ADDENDUM No. 1 TO PLANS AND CONTRACT DOCUMENTS

**EAST MARSH ISLAND MARSH CREATION
POST-CONSTRUCTION MAINTENACE EVENT**

CWPPRA NUMBER: TV-21

**ADDENDUM TO BID DOCUMENTS
EAST MARSH ISLAND MARSH CREATION
POST-CONSTRUCTION MAINTENANCE EVENT
IN IBERIA PARISH, LOUISIANA
CWPPRA NUMBER: TV-21**

| COASTAL PROTECTION AND RESTORATION AUTHORITY 450 LAUREL ST. STE. 1501 BATON ROUGE, LOUISIANA 70801 | | EAST MARSH ISLAND MARSH CREATION POST-CONSTRUCTION MAINTENANCE EVENT | | SHORELINE PROTECTION LAYOUT |

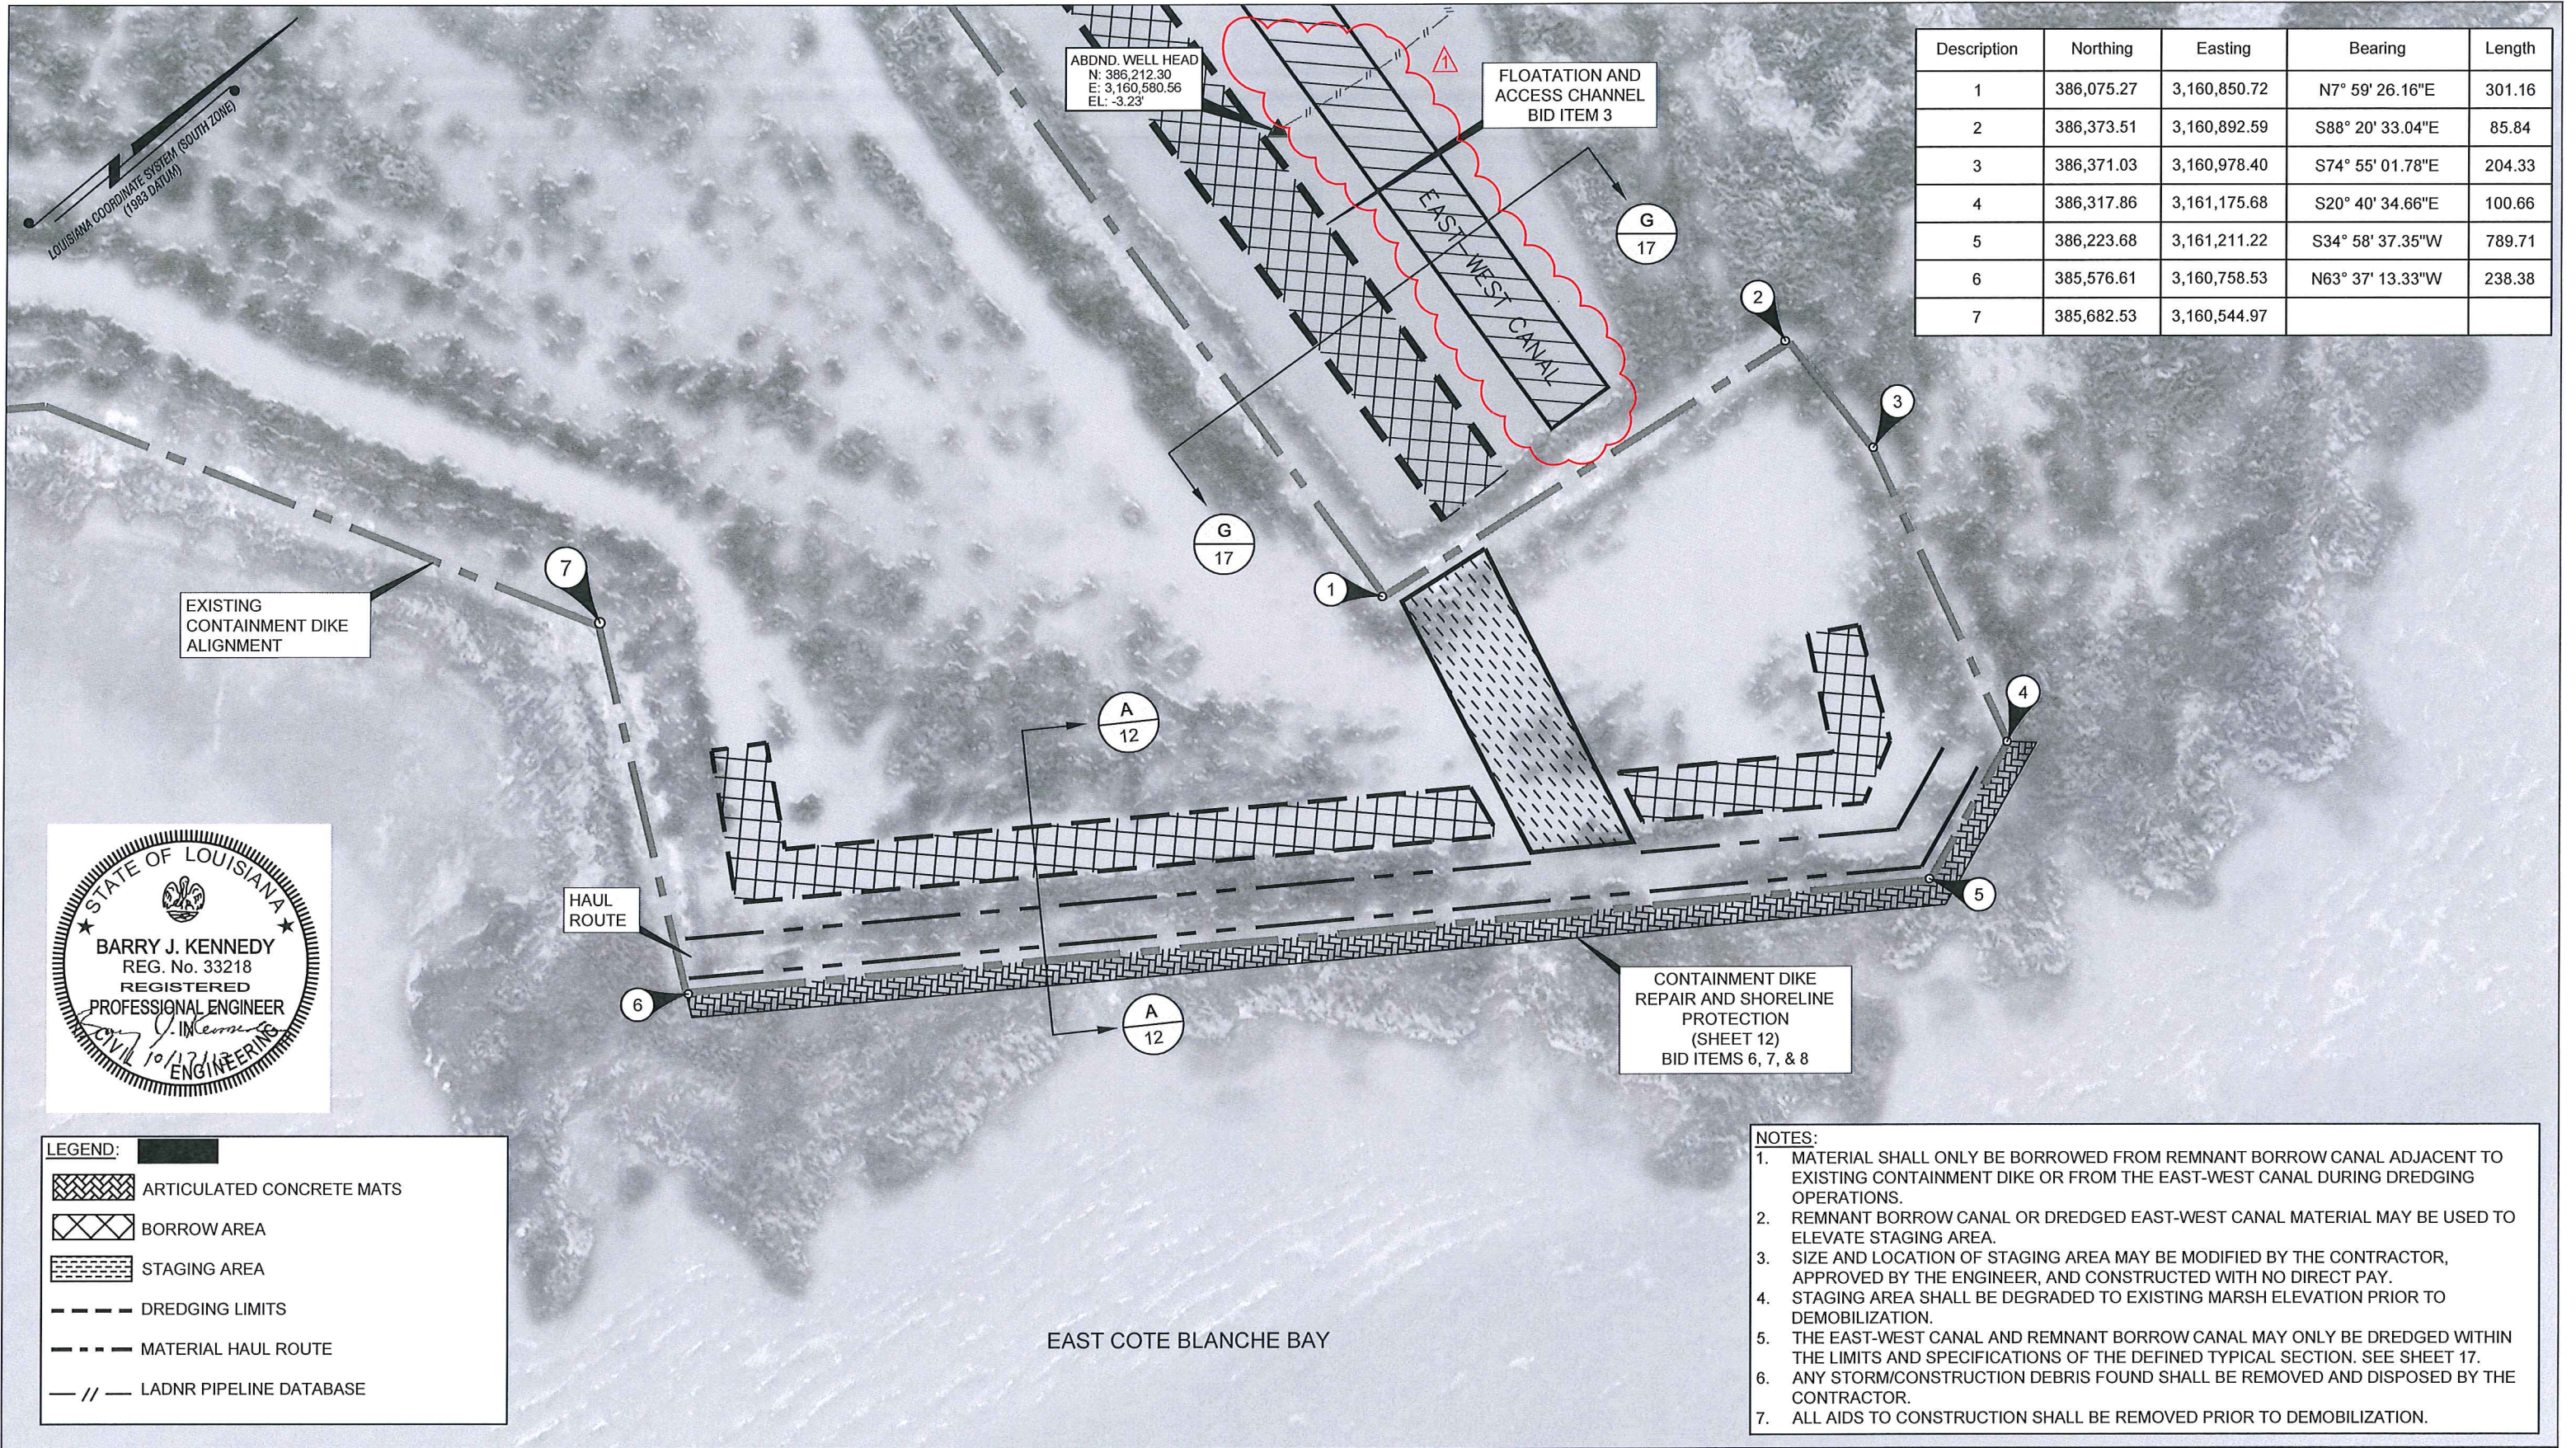
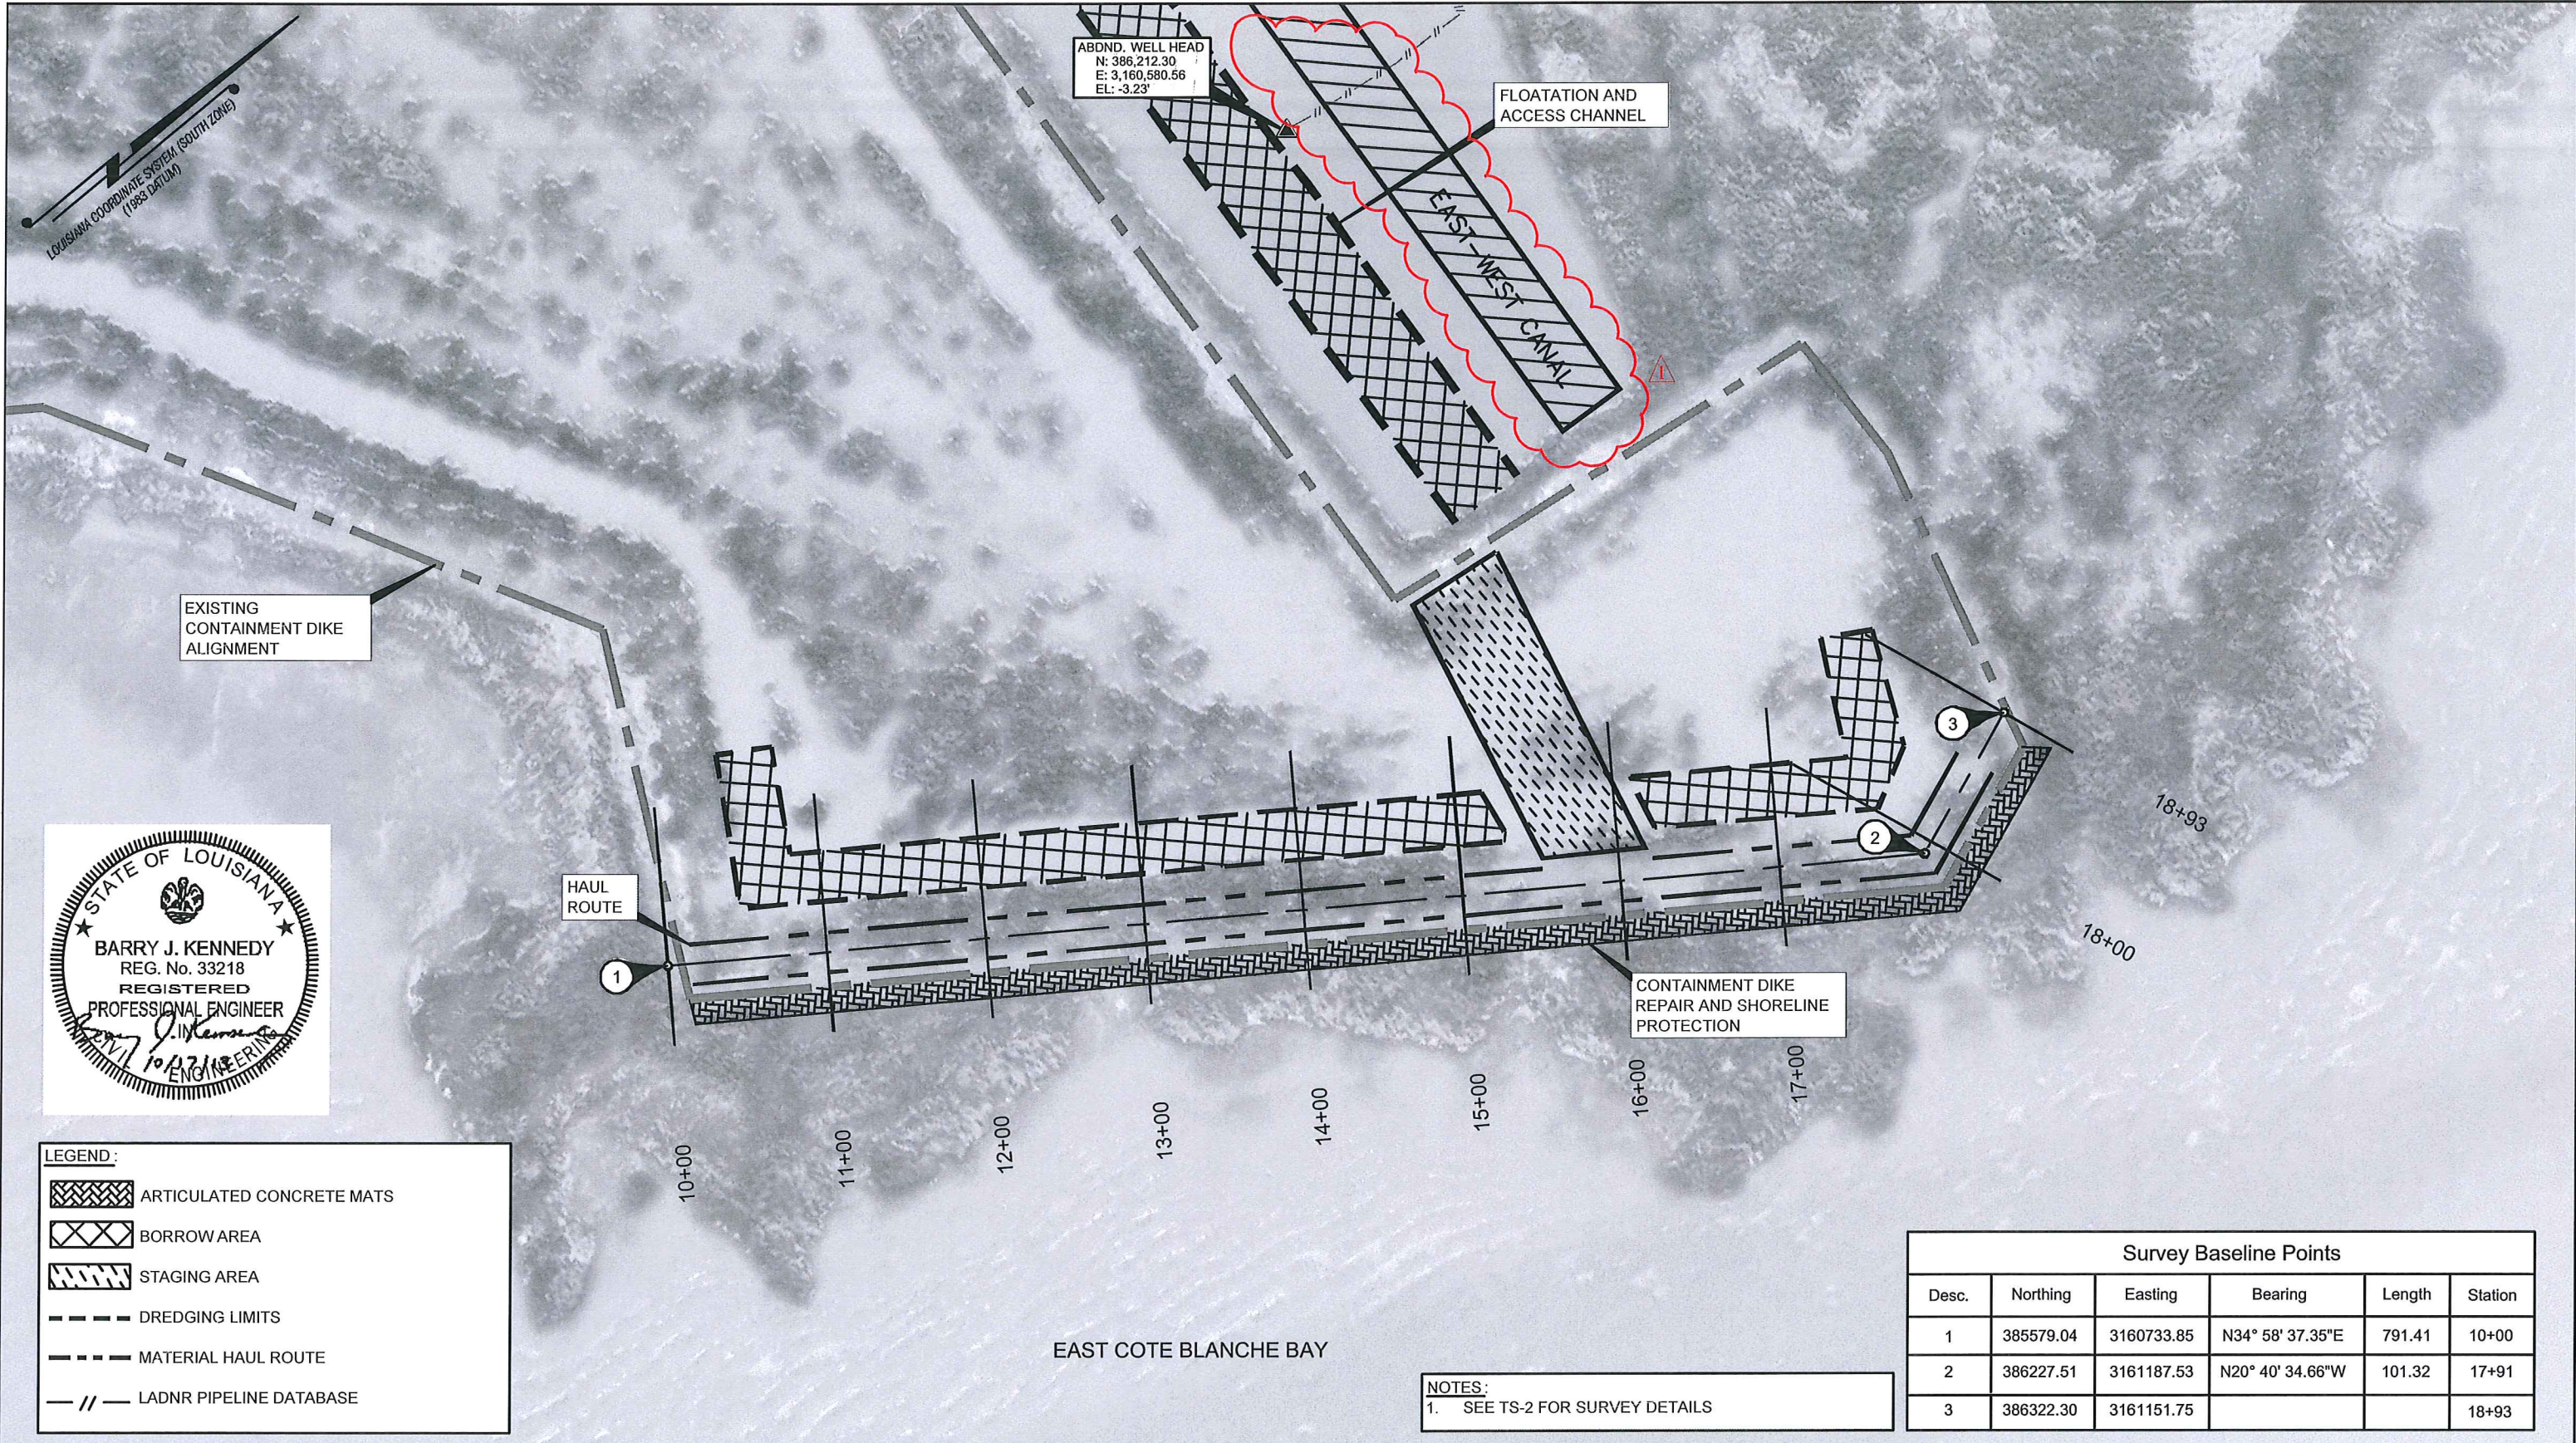
- 1.4.** Material dredged from the East-West Canal may be “Side-Cast” the entire length of the canal. See Plan Sheets 4 through 7 in Attachment A of this Addendum.

- 1.7.** An inconsistency in dredging limits was brought to attention. These inconsistencies have been addressed and shown on the revised Plan sheets presented in Attachment A of this Addendum.
